v3/30 MAR 2011 | E1100277-V1

SYSTEM: aLIGO

SUB-SYSTEM: SUJS

PART NAME: FRONT AND REAR PLATE NOISE TABLECLOTH

D060311 v3  
SHEET 2

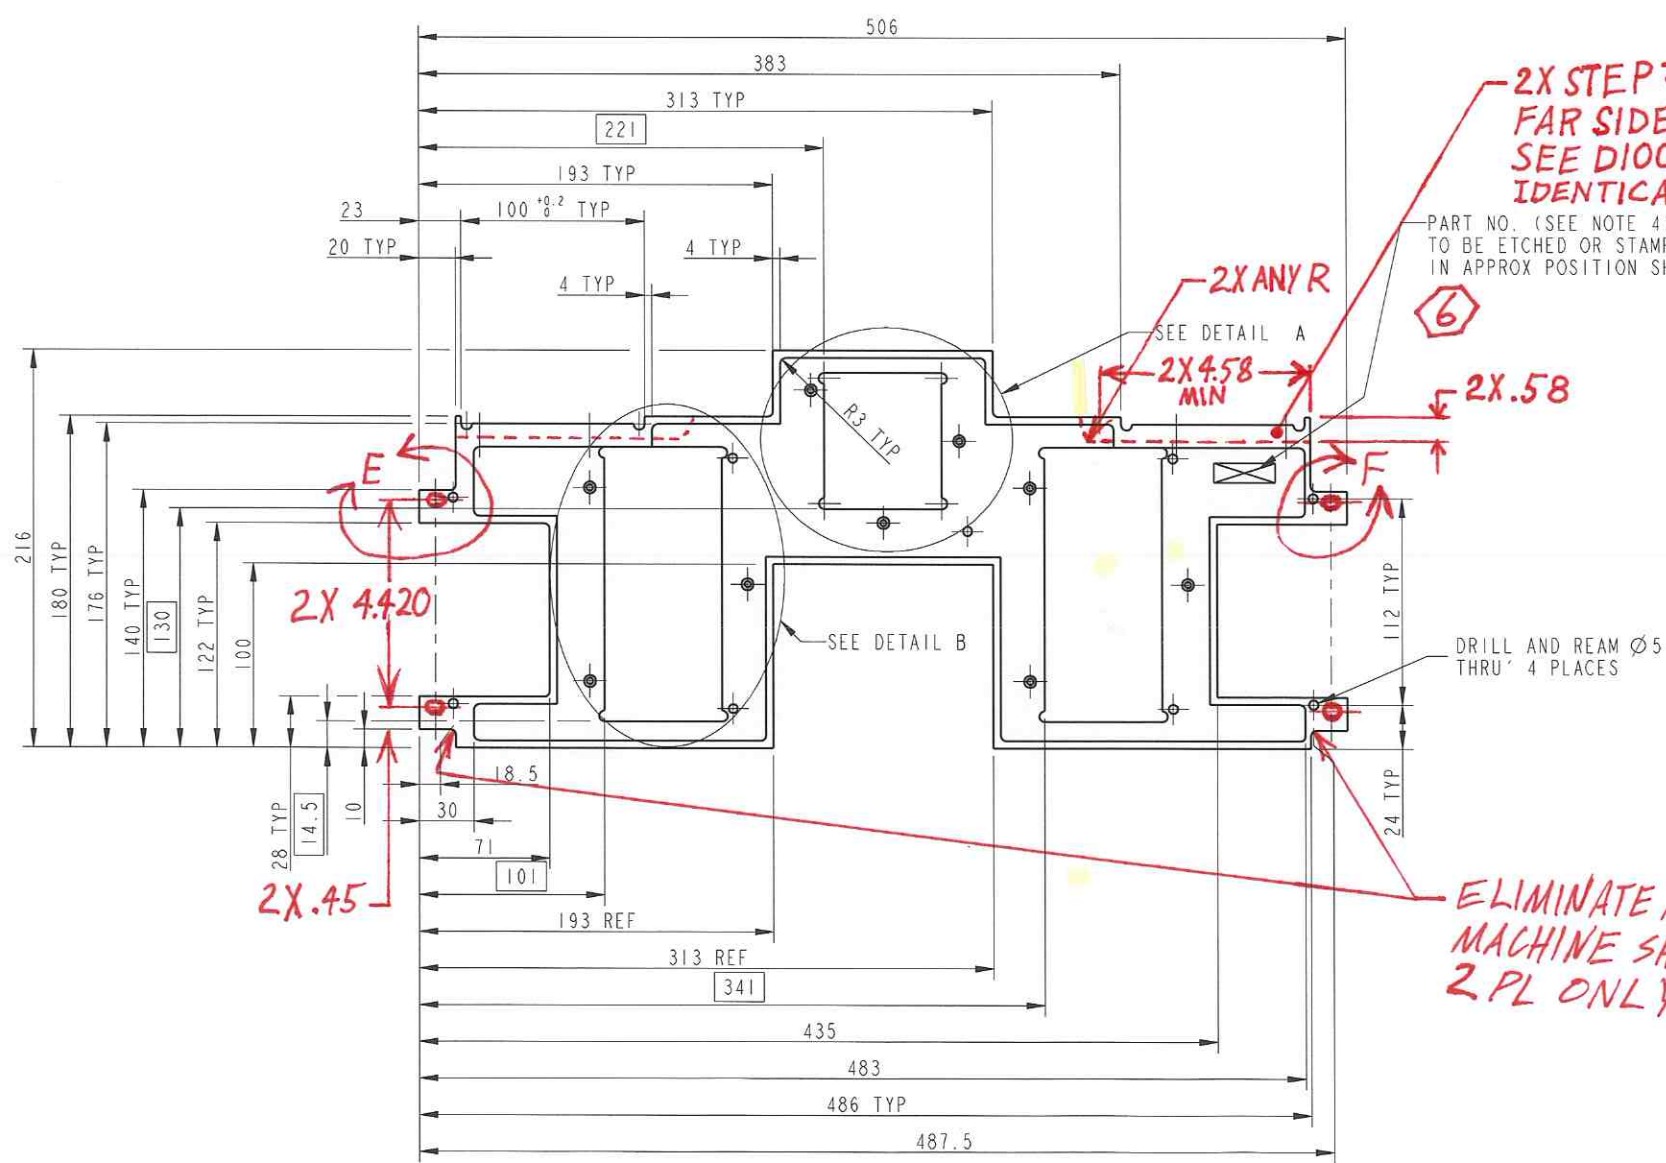
5. REDLINE DIMENSIONS ARE IN INCHES.

6. MARK OUT OLD REVISION LABEL AND REPLACE WITH "v3".

ELIMINATE RADIUS MACHINE SHARP 2 PL ONLY
